HISTORIC AND DESIGN REVIEW COMMISSION December 06, 2017

HDRC CASE NO: 2017-586

ADDRESS: 430 BURLESON ST

TYPE OF WORK: Installation of front yard fencing

option A: option B:

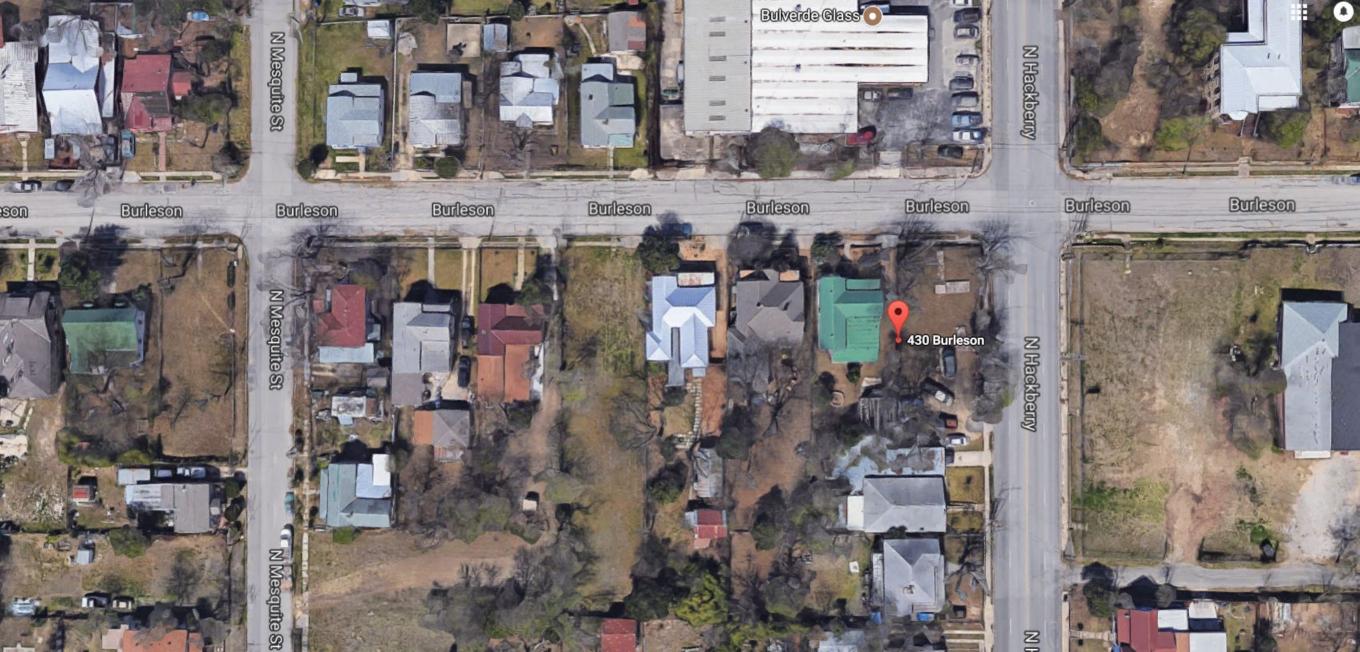
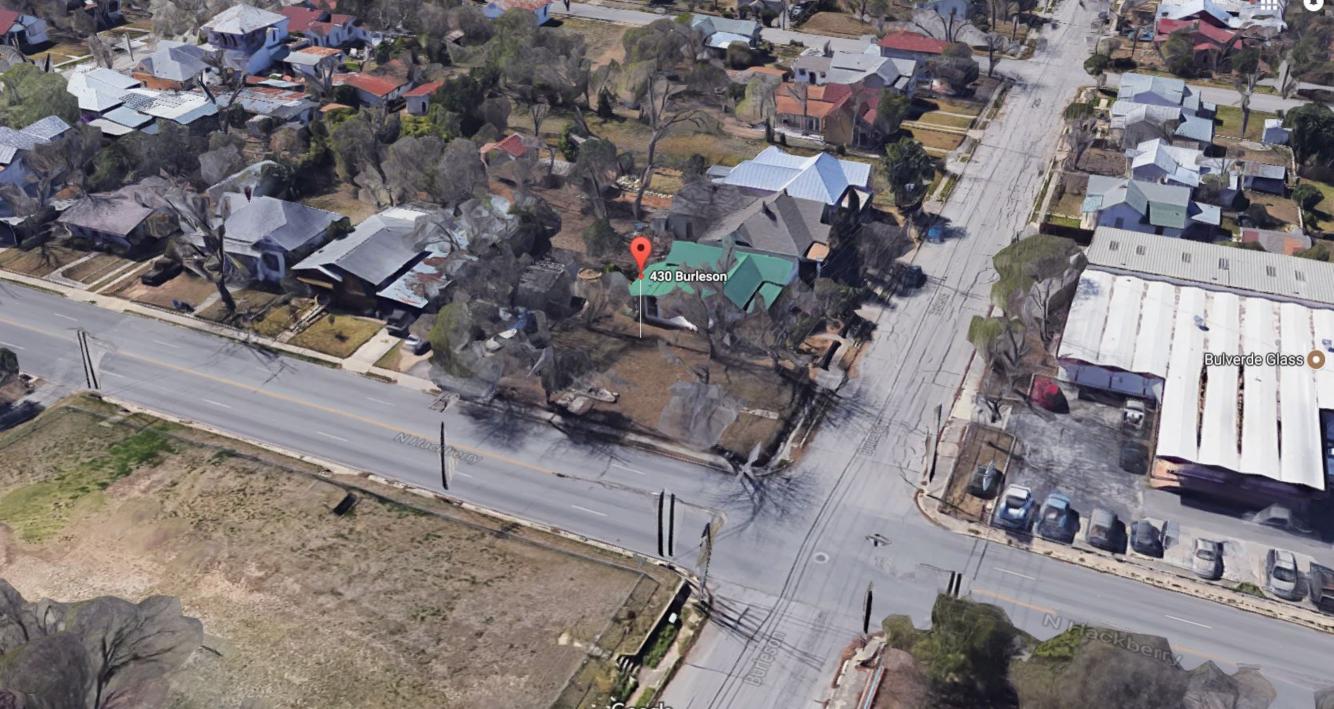
- **c.** The applicant has proposed two options for cattle panel fencing around the front yard of the property: Option A extends across the driveway to the rear property line and Option B returns to the rear corner of the home without crossing the driveway. Staff finds that Option B is more consistent with the Guidelines in terms of location. The proposed wood and cattle panel construction is compatible with the new construction

Staff recommends approval of option B with the stipulation that the fence will not exceed four feet in height at any portion of the front yard.
